Classification: Company Internal/Proprietary		
Drawing Title: FMUM-RT117X		
Page Title: 02_block_diagram.SchDoc		
Size B	Document Number 725002	Rev 01
Date: 4/5/23		Sheet 2 of 9

Drawing Title: **FMUM-RT117X**

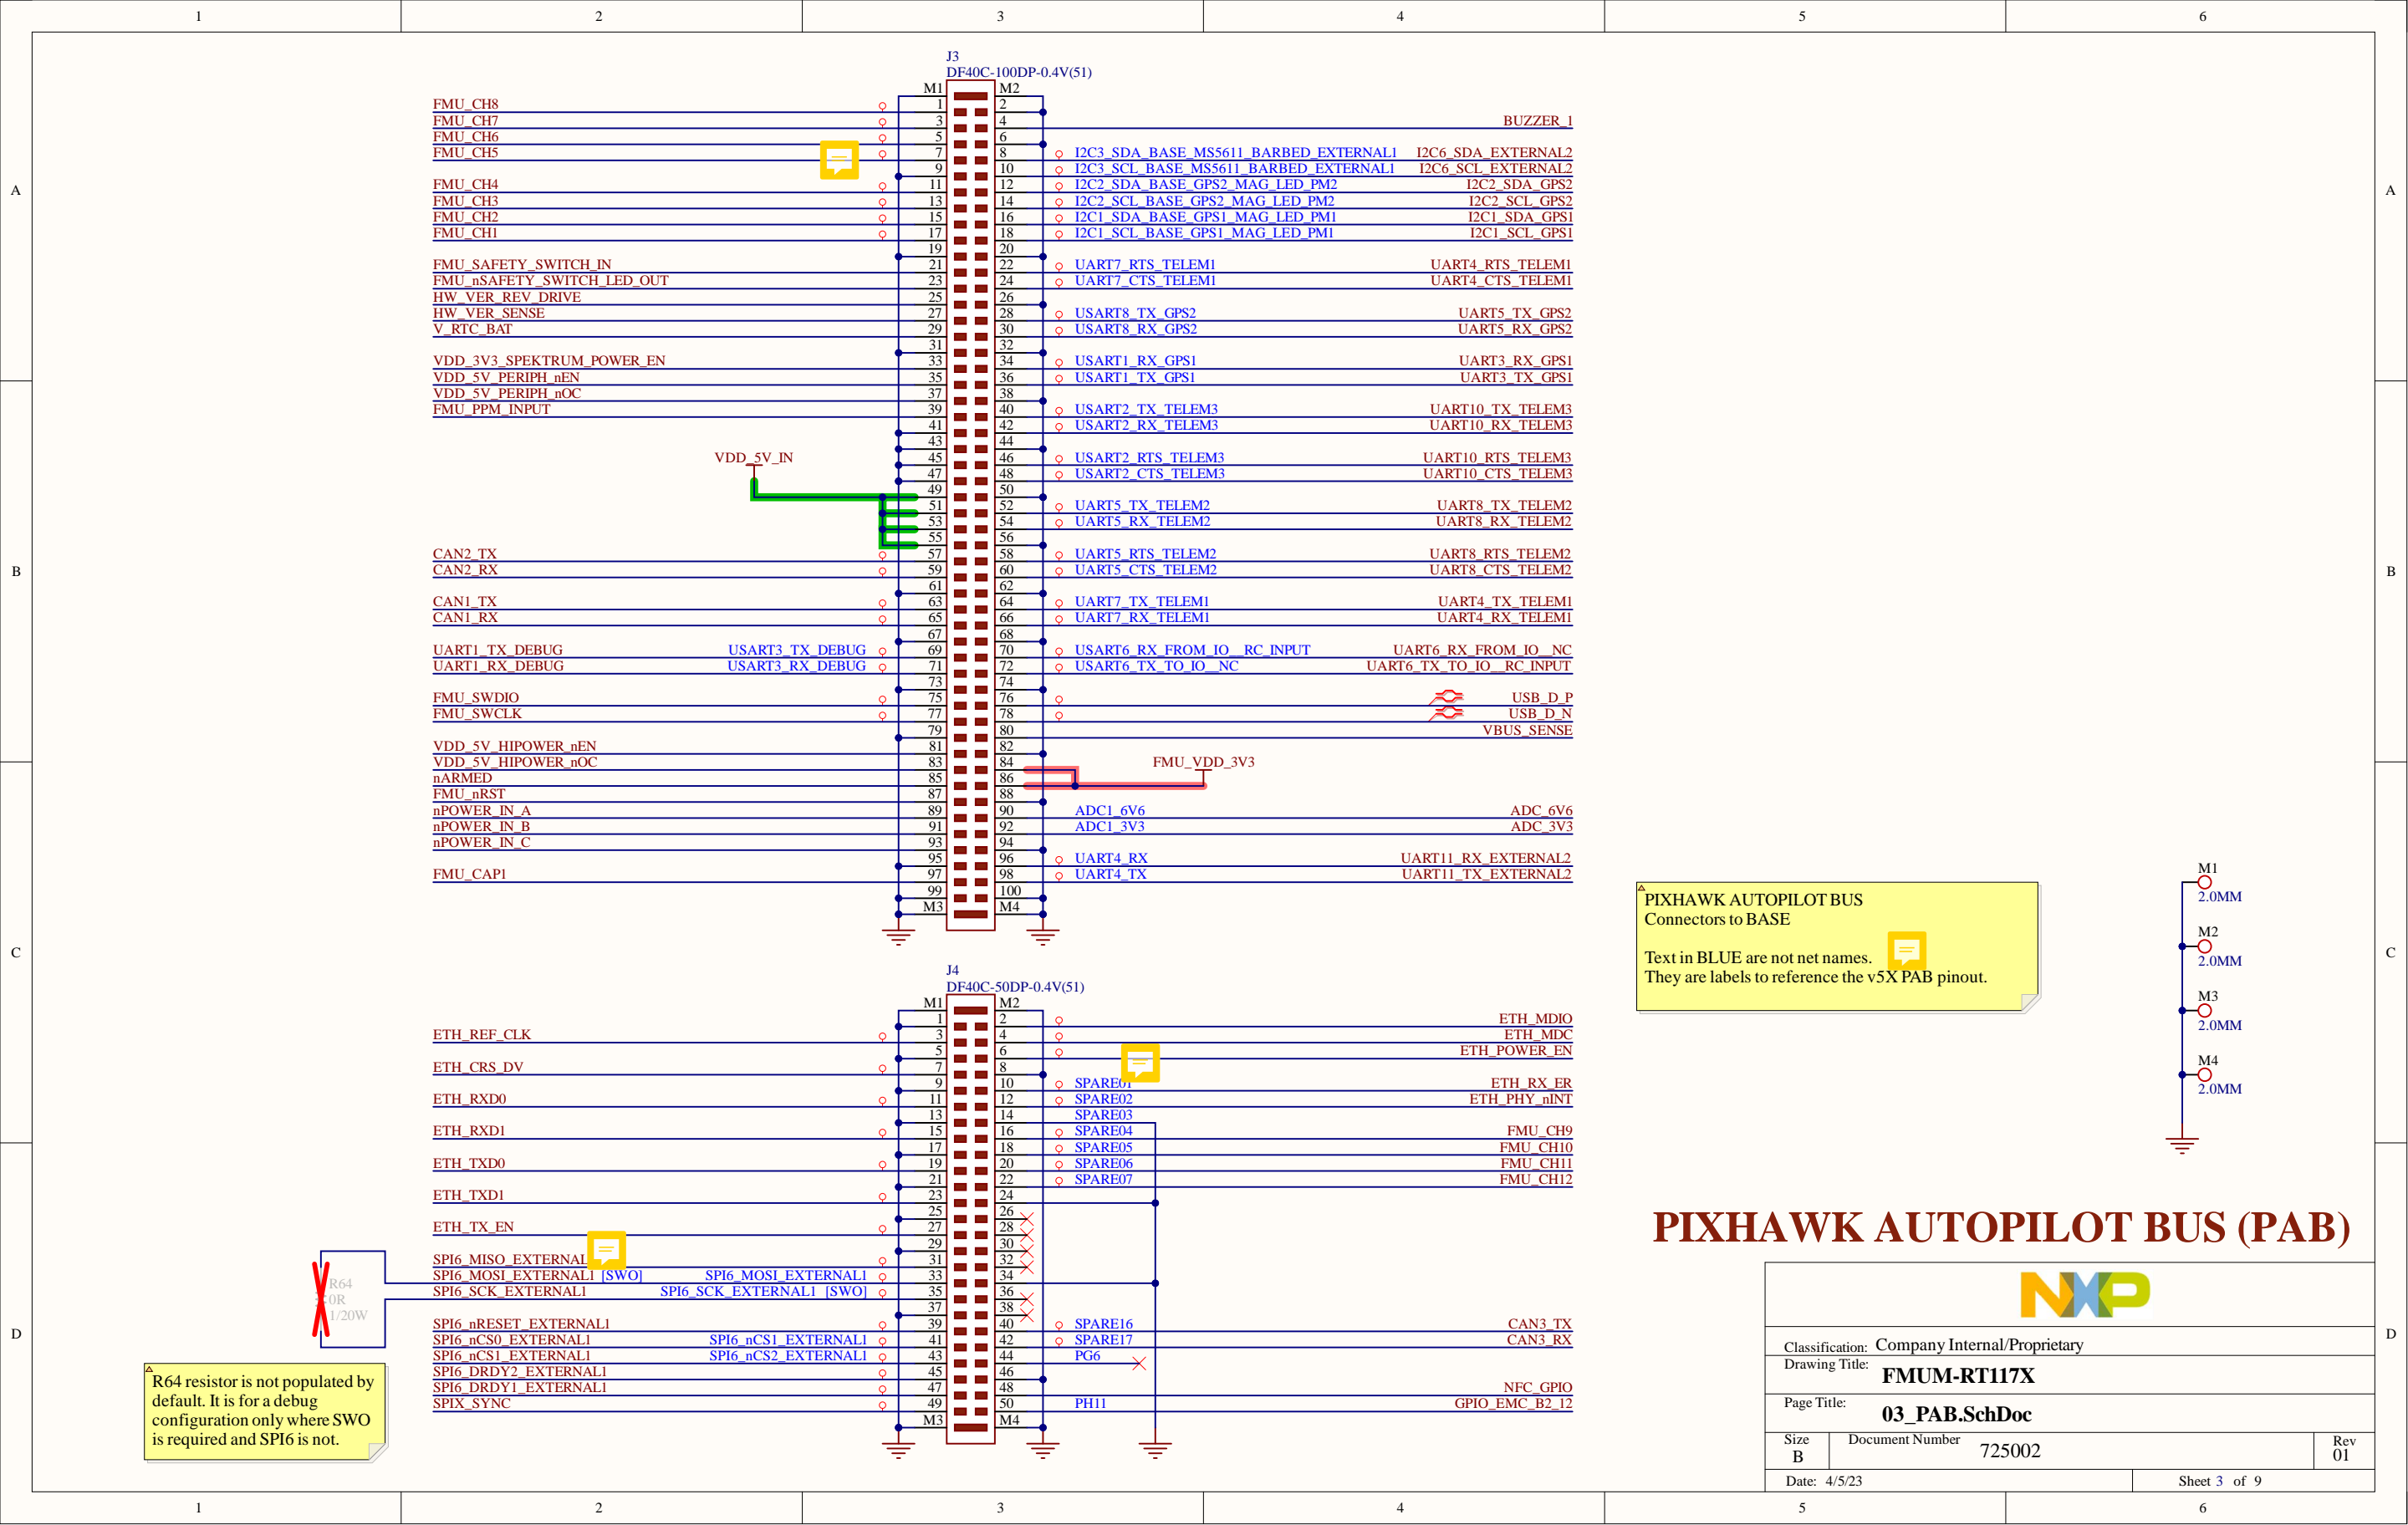
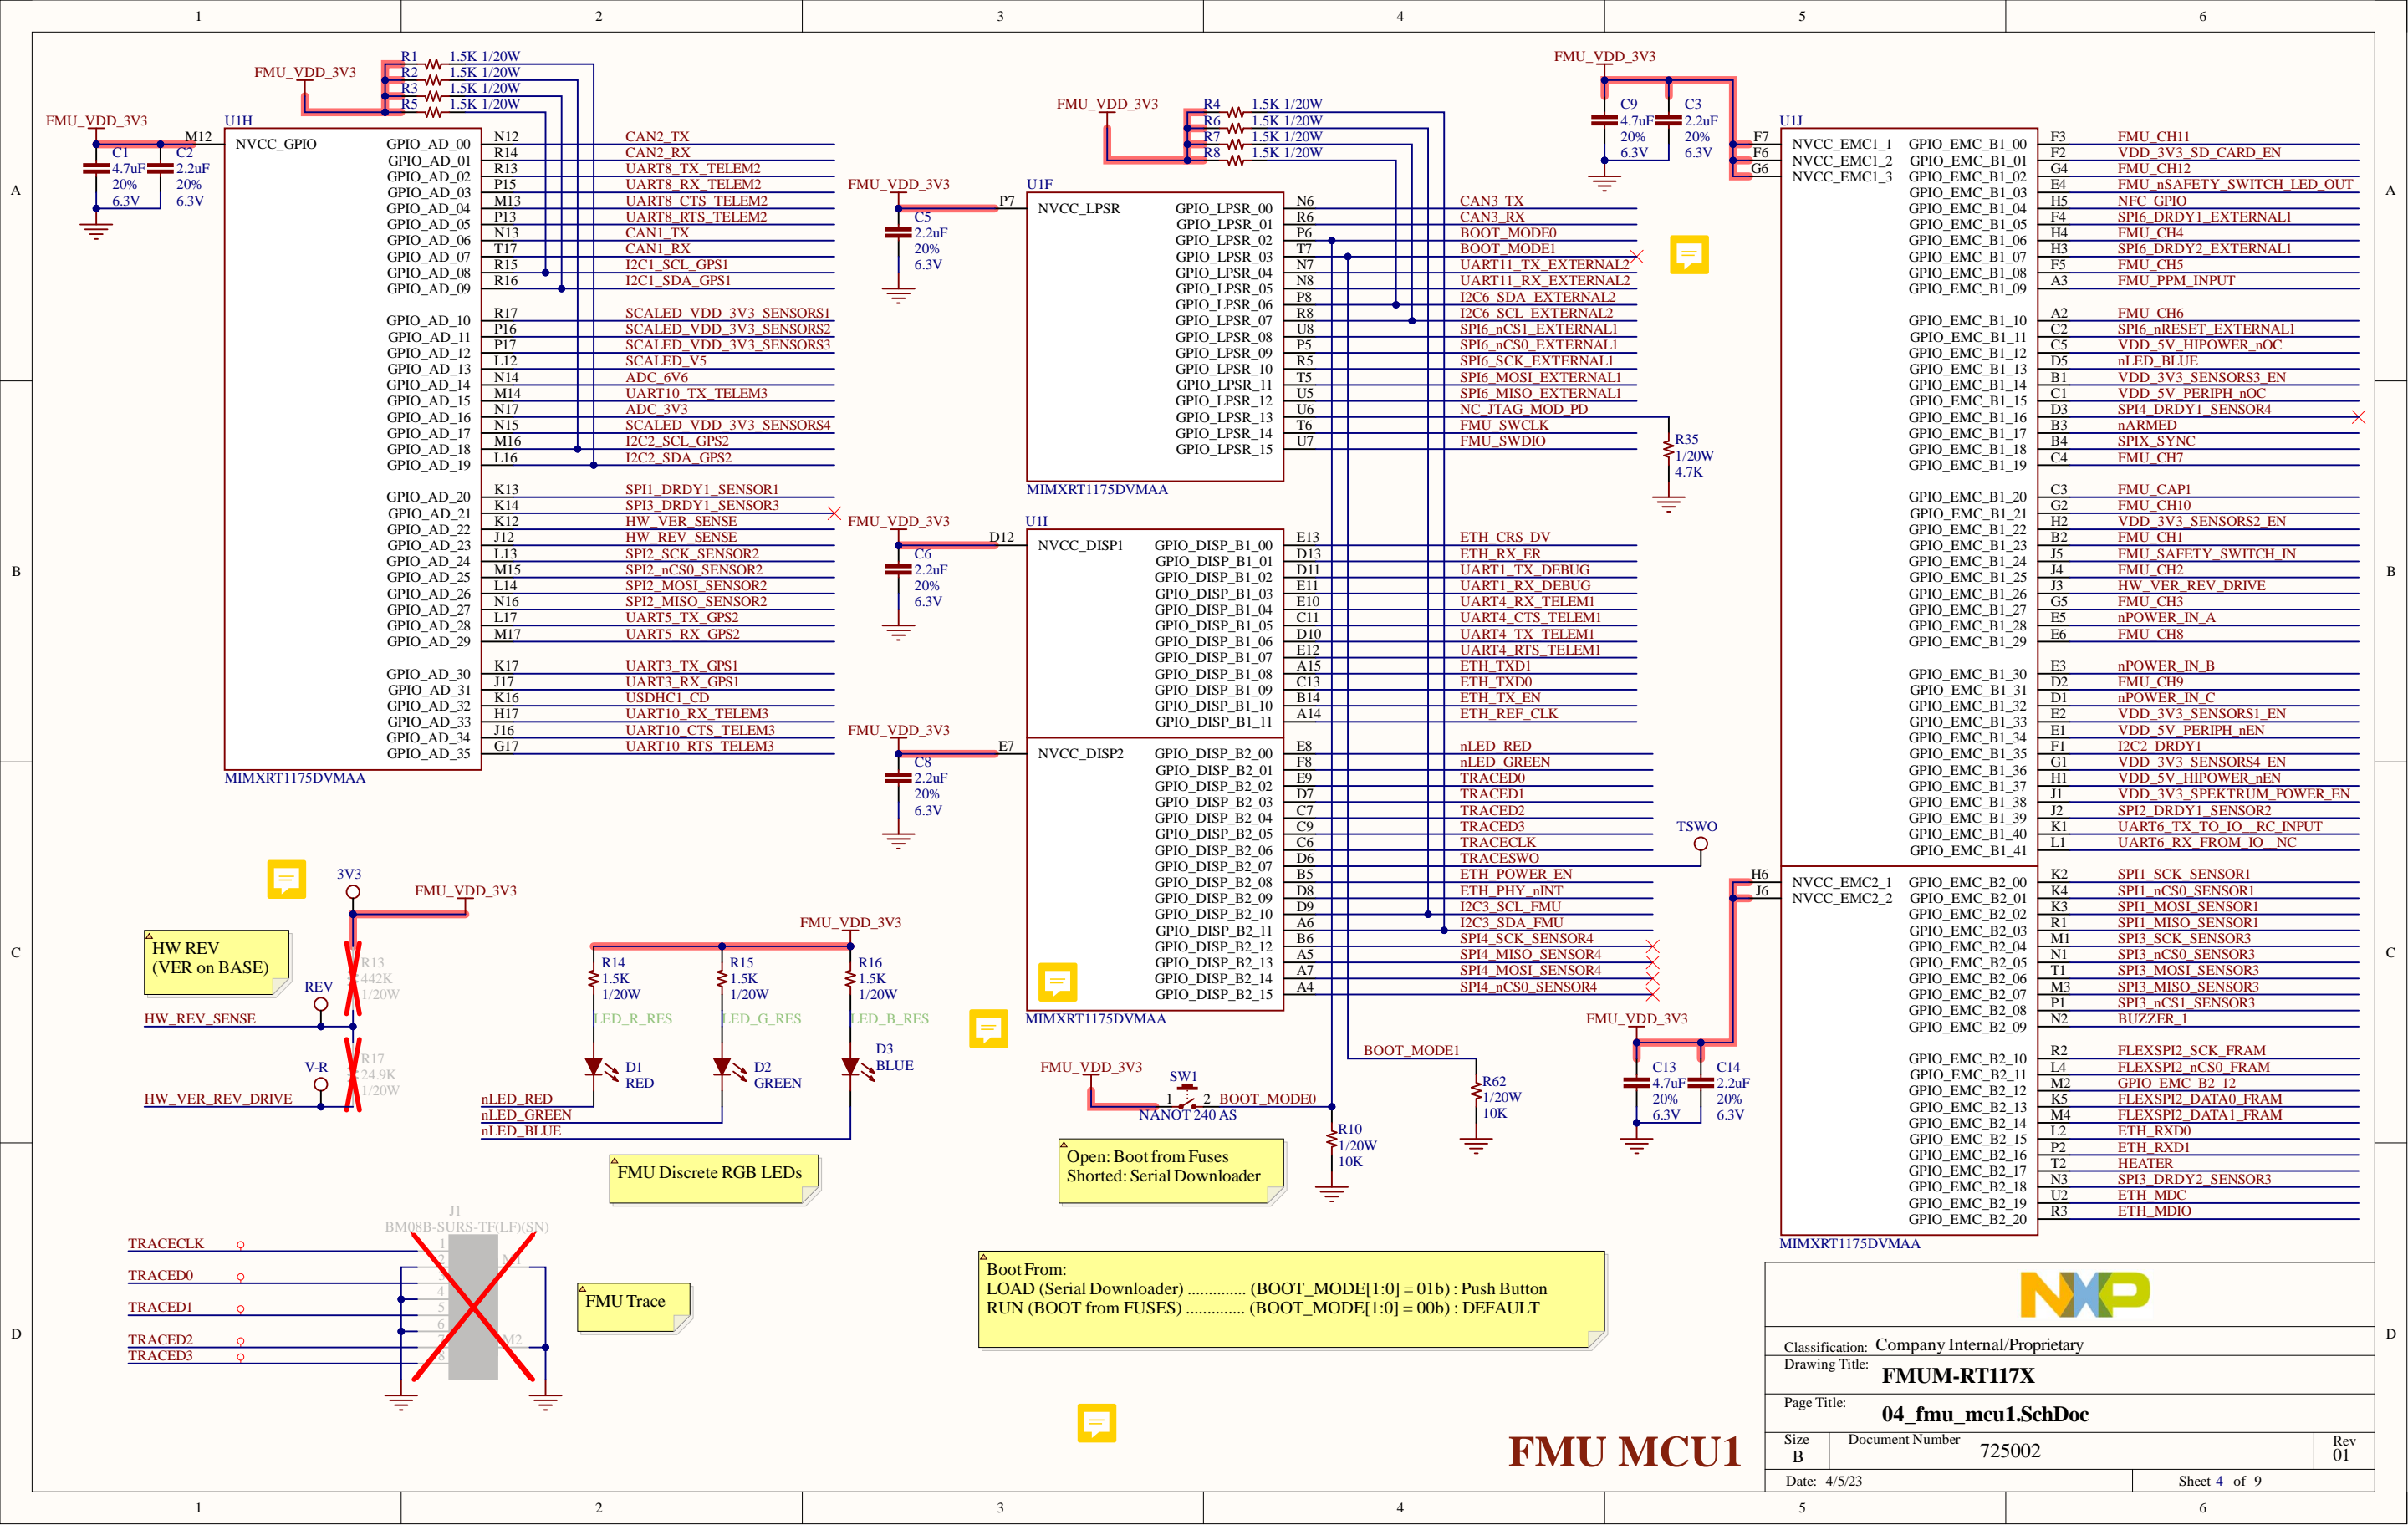
This block diagram needs to be updated
